LAKE VERMONT NORTHERN EXPANSION
EPBC REFERRAL – IESC RESPONSE

PREPARED FOR
BOWEN BASIN COAL PTY LTD

Author:	Heath Carney
Project Manager:	Heath Carney
Name of Client:	Bowen Basin Coal Pty Ltd
Name of Project:	Lake Vermont Northern Expansion
Title of Document:	EPBC Referral – Response to IESC Final Advice
Document Version:	Final

Figure 1 Proposed Groundwater Monitoring Bores

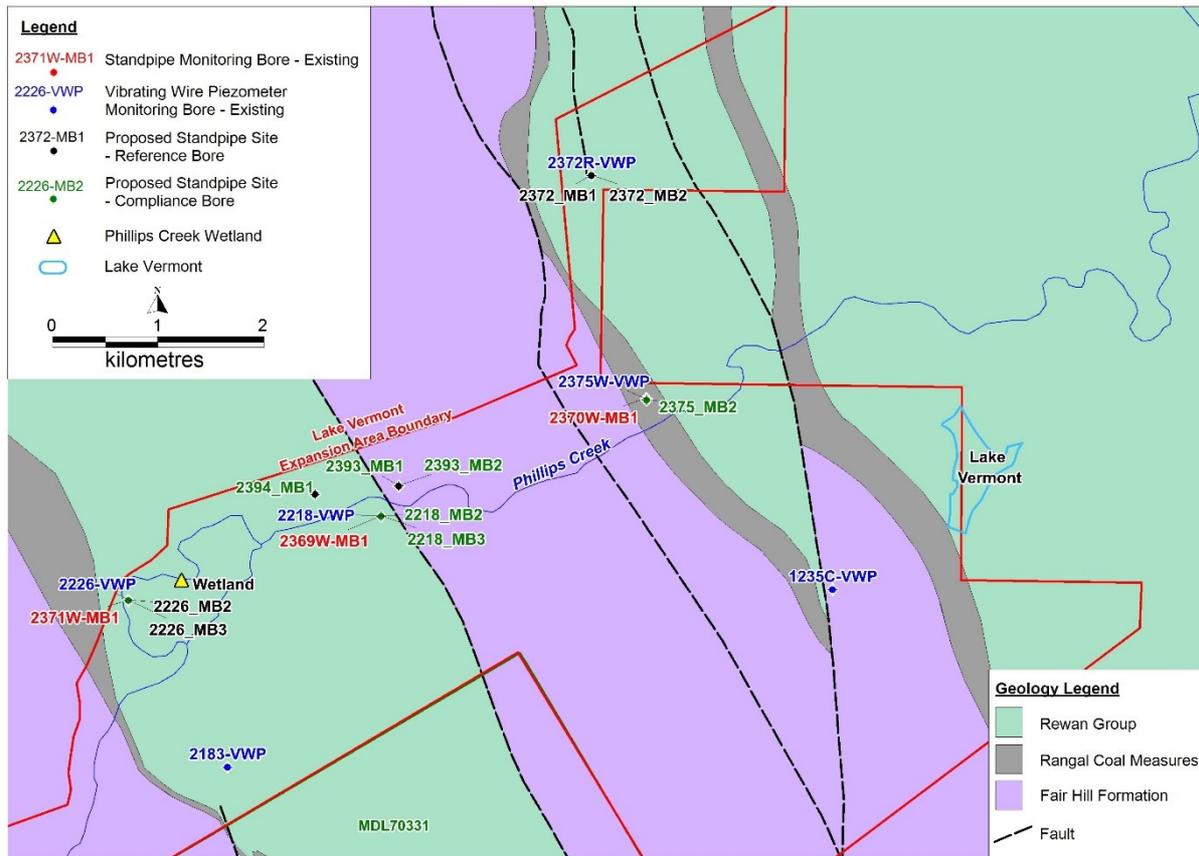
In their response to DoEE's Question 1, regarding the adequacy of groundwater and surface water assessments to provide reasonable estimations of the likely impacts to water resources, IESC recommended that additional collection and analysis of site-specific baseline data is required, with consideration given to:

With these predominantly dry conditions, collection of baseline surface and groundwater data to assess spatial and temporal variability is not possible within the assessment timeframe. Therefore, a groundwater monitoring program has been proposed, and will be incorporated into the Lake Vermont Environmental Authority. The proposed monitoring bore network comprises a combination of existing vibrating wire piezometer (VWP) bores (for monitoring of water level) and standpipe bores (for monitoring of both water level and water quality). The network has been designed to monitor the major groundwater units that are to be mined or impacted at site and to give adequate spatial and vertical coverage across the site. The proposed program comprises a combination of existing vibrating wire piezometer (VWP) bores (for monitoring of water level) and standpipe bores (for monitoring of both water level and water quality). The network has been designed to monitor the major groundwater units that are to be mined or impacted at site and to give adequate spatial and vertical coverage across the site. The proposed network is illustrated in Figure 1 below and the proposed standpipe monitoring bores and target lithology are listed in Table 1.

Figure 2 pH in Sediment Dams (Jellinbah Group 2017)

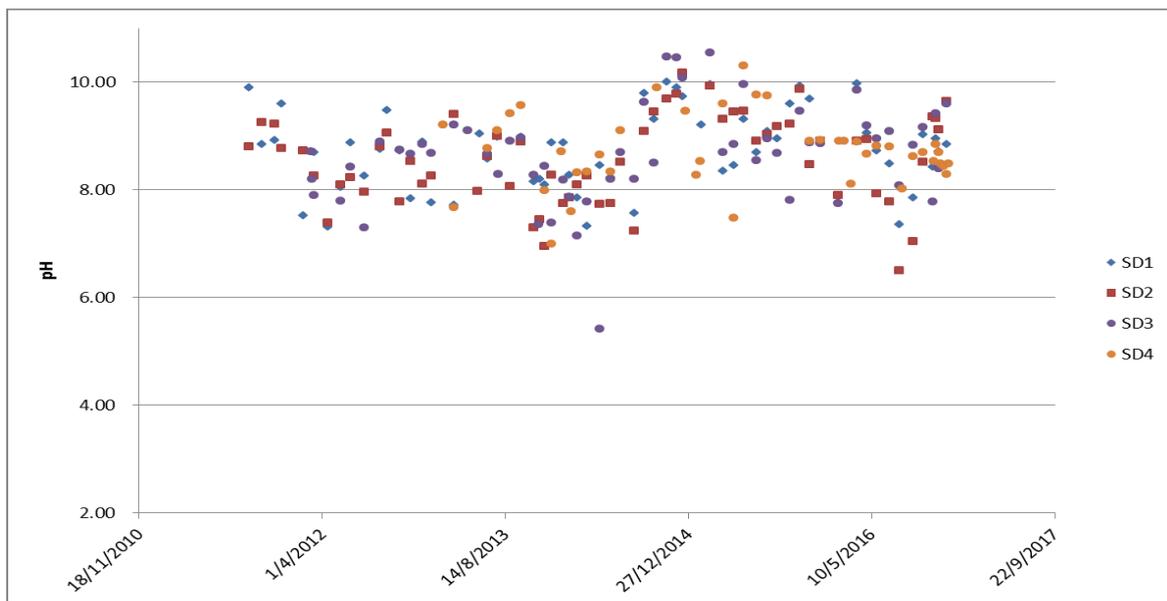
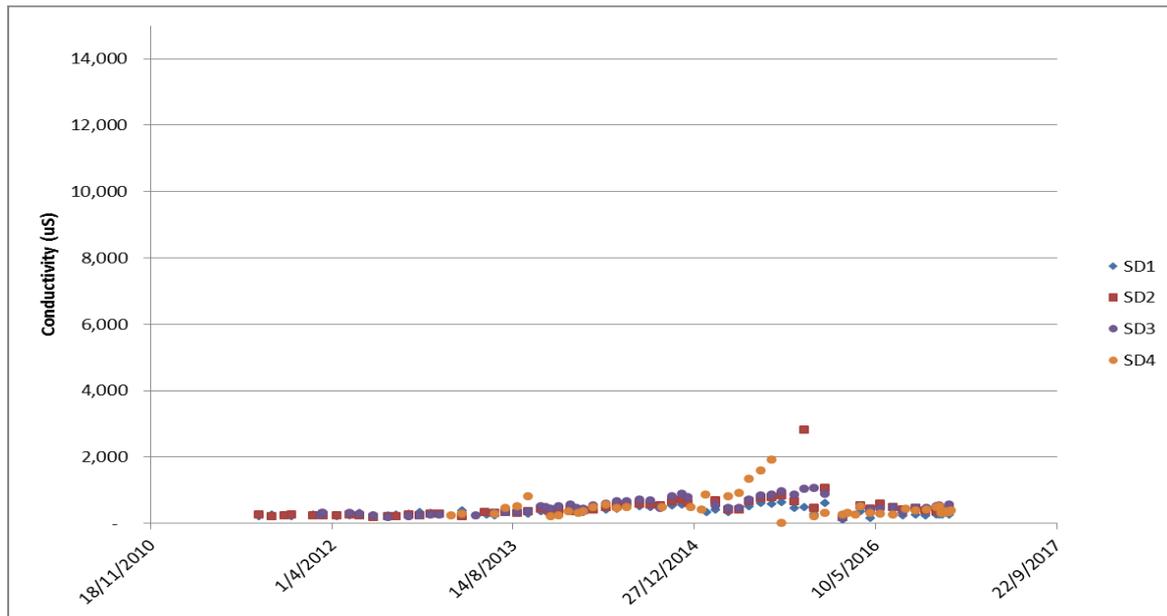
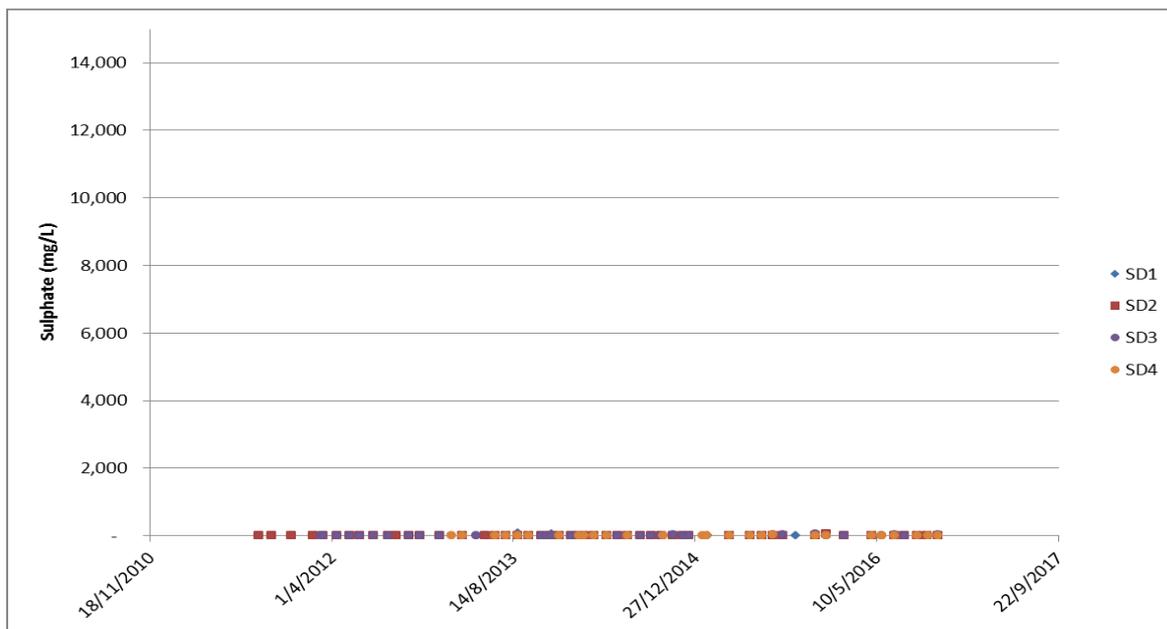
Impacts to water quality from sediment dam overflows was addressed in Section 2.3.3 of the Response to DoEE’s Information Request. The design of both the on-site Surface Water Management System, to ensure mine-affected water is not discharged through the stormwater system, and the sizing of the proposed and existing sediment dams ensures that the downstream impacts from these structures will not be significant.

- Water quality is typically slightly to moderately alkaline, ranging from 7 to 9 pH units (Figure 2).
- Salinity levels are fresh and typically range between 200µS/cm to 500µS/cm (Figure 3).
- Sulphate levels are very low (<10 mg/L) in all stormwater dams (Figure 4), with the exception of a single high sulphate reading of 91 mg/L recorded in Sediment Dam 1.

Comparing the sediment dam water quality to mine affected water on the existing Lake Vermont site indicates that the site’s water management strategy is effectively separating the mine affected and clean stormwater water sources. Stormwater captured in the sediment dams is typically fresh (EC levels of 200 – 500 $\mu\text{S}/\text{cm}$), slightly to moderately alkaline, and has very low sulphate levels (typically < 10 mg/L). Mine affected water is brackish to saline (typically up to 6000 $\mu\text{S}/\text{cm}$) and slightly alkaline to alkaline with high sulphate levels (up 2000 mg/L).

Figure 5 Simulated Final Void Storage Water Level

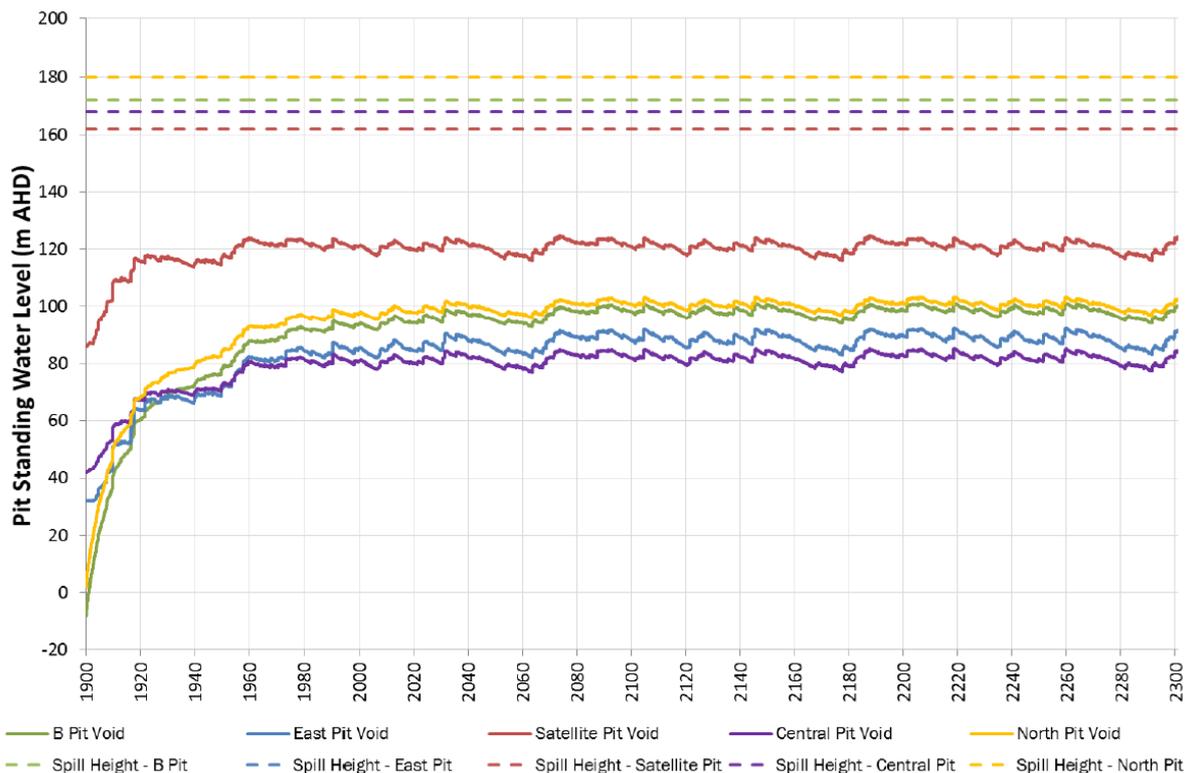
Potential interaction between Phillips Creek and Isaac River floodwaters and the final voids (particularly Pit B and the Satellite Pit) is addressed in detail in the attached response from WRM Water and Environment (Appendix C). In summary, surface water and flood modelling demonstrated that it will be possible to design a final landform that will be resistant to flooding inputs from Phillips Creek and the Isaac River.

As shown in Figure 5, modelling of water levels, based on groundwater inflows and surface water inputs (which will be minimal as the voids do not have a significant catchment beyond their own boundaries), indicates that long term water levels in the Central, North, B and East Pits would be expected to stabilise between 82m AHD and 101m AHD after approximately 120 years. For the Satellite Pit void, the level stabilises at a higher level – around 121m AHD after approximately 60 years.

When compared to regional groundwater levels, it can be concluded that void water levels will remain below groundwater levels, leaving the pits to act as a sink. These comparisons are shown in Table 6 below:
